MILITARY SPECIFICATION SHEET

BATTERY, RECHARGEABLE, NICKEL-CADMIUM, VENTED, AIRCRAFT
BB-716/A

This amendment forms a part of MIL-B-49450/8(ER), dated 16 January 1987, and is approved for use within the Laboratory Command, Department of the Army and is available for use by all Department and Agencies of the Department of Defense.

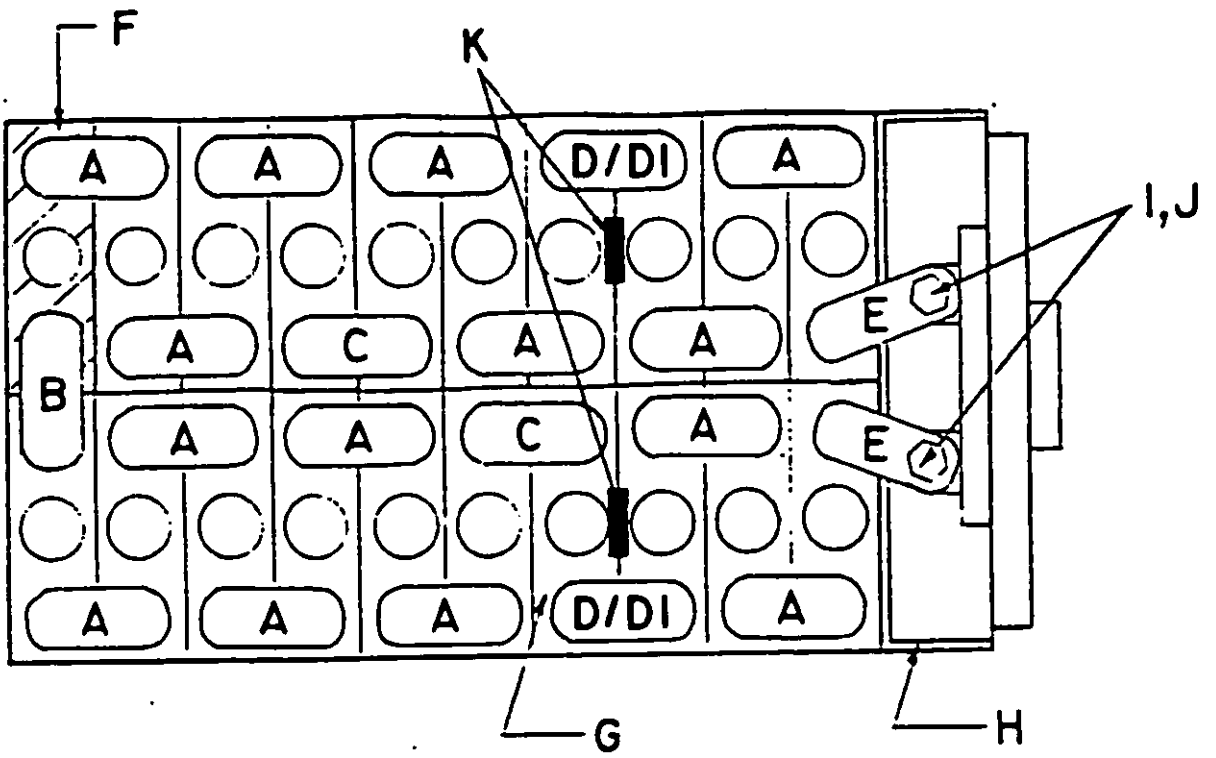
Delete Figure 3 and substitute the following:
